CHANGE ORDER NUMBER 1

4B: Third Party Accommodation. Third party requested work. This Change Order adds relocation of the existing Brushy Creek Municipal Utility District (BCMUD) water line along CR 176 and revises the City of Georgetown water line relocations on the project.

Project: 1901-285Roadway: CR 176 at RM 2243

WILLIAMSON COUNTY
CR 176 AT RM 2243 INTERSECTION
COG AND BCMUD WATER ADJUSTMENTS
AND BCMUD 24" RAW WATERLINE RELOCATION

DRAWING NO:
WT-16

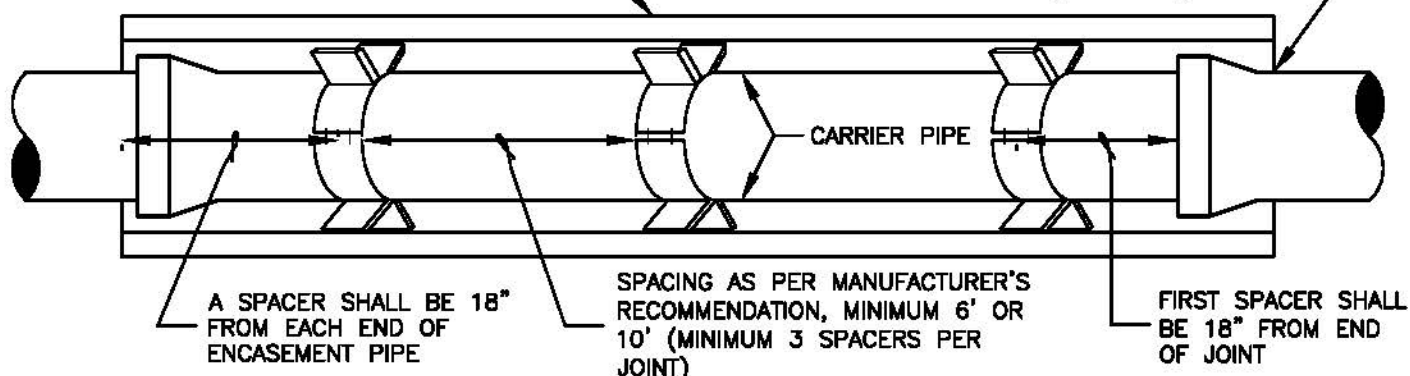
The relocations for BCMUD include installing a new portion of water line in an encasement because the new roadway crosses the water line and adding a 4" Combination Air Release Valve Assembly (CARV), salvaging the old CARV and removing the existing 4" Gate Valve. The revisions to the City of Georgetown water line include adjustment of the existing 2" line and deletes items to adjust the existing 4" water line.

SHEET
C-003
3 OF 10

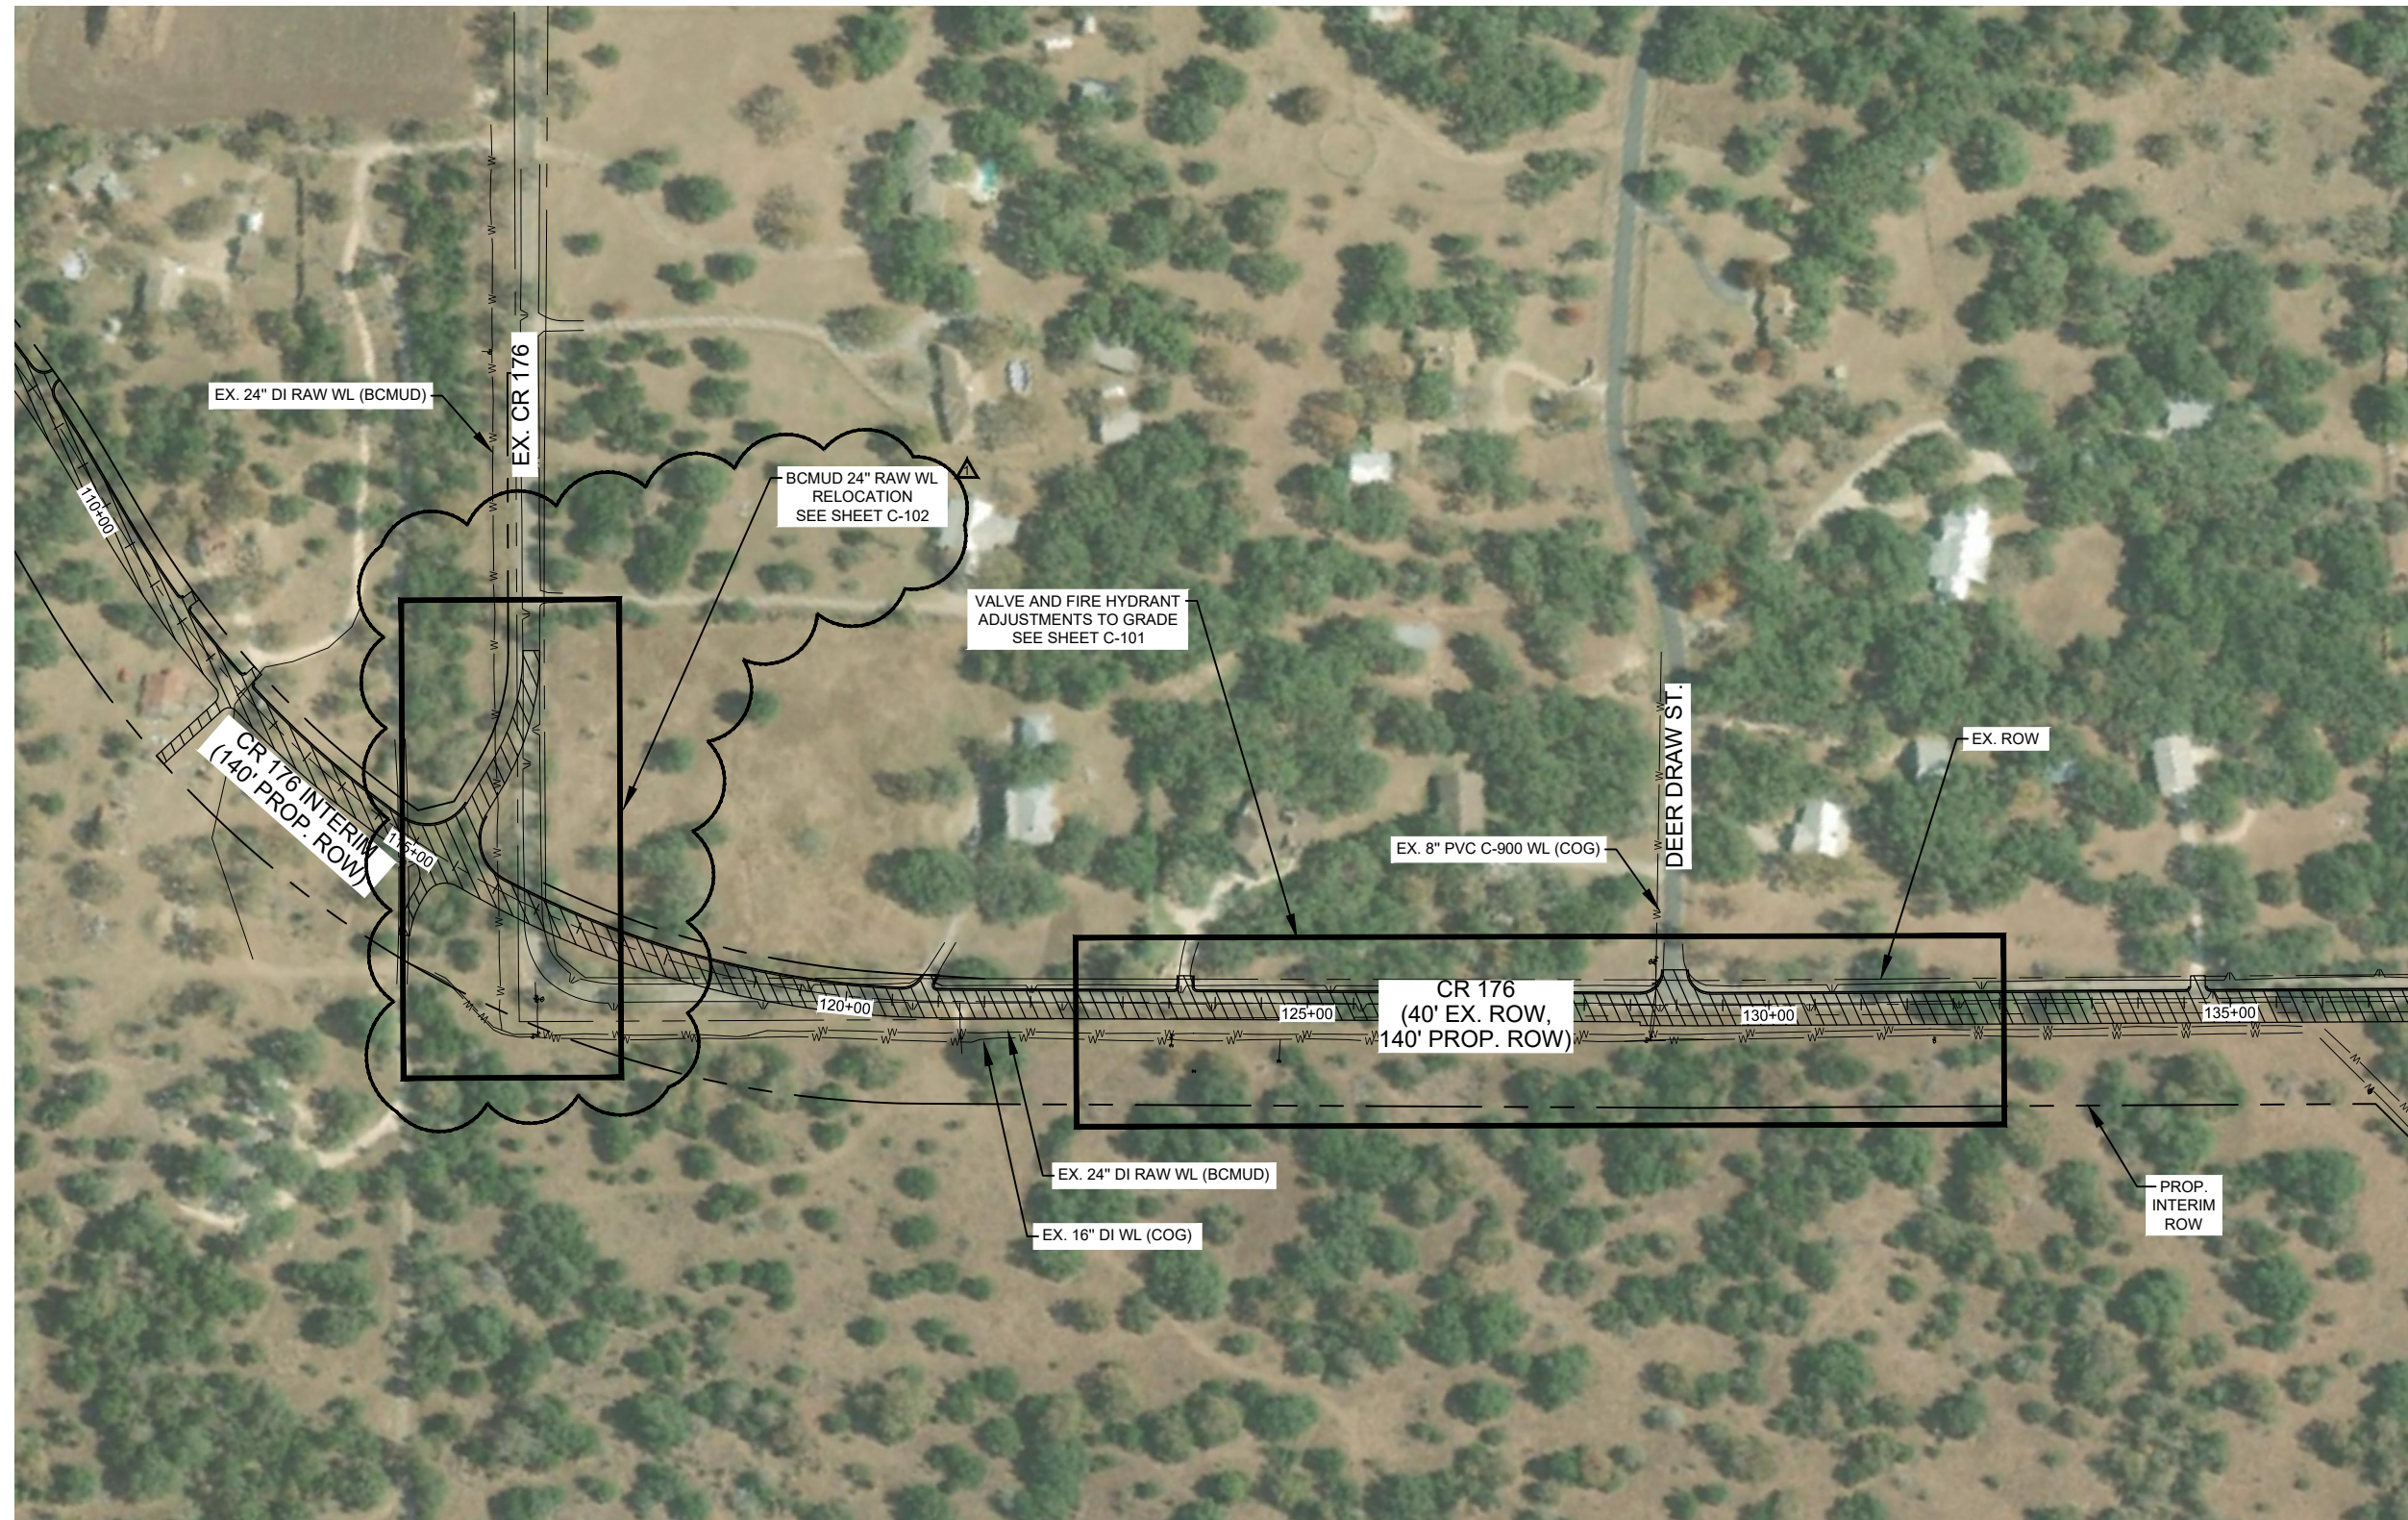
BCMUD 24" CONNECTION TO EXISTING RAW WATER LINE

ADDED NEW SHEET

- THE CONTRACTOR SHALL SUBMIT A PLAN DETAILING THEIR PROCEDURES, PROPOSED METHODS, EQUIPMENT AND MATERIALS TO INCLUDE THESE ITEMS ABOVE FOR REVIEW AND APPROVAL PRIOR TO PROCEEDING WITH MAKING THIS CONNECTION.

- THE NEW LINE SEGMENT SHALL BE FLUSHED TO REMOVE ANY SEDIMENT AND DEBRIS AND SUCCESSFULLY PRESSURE TESTED PRIOR TO PLACING IN SERVICE.
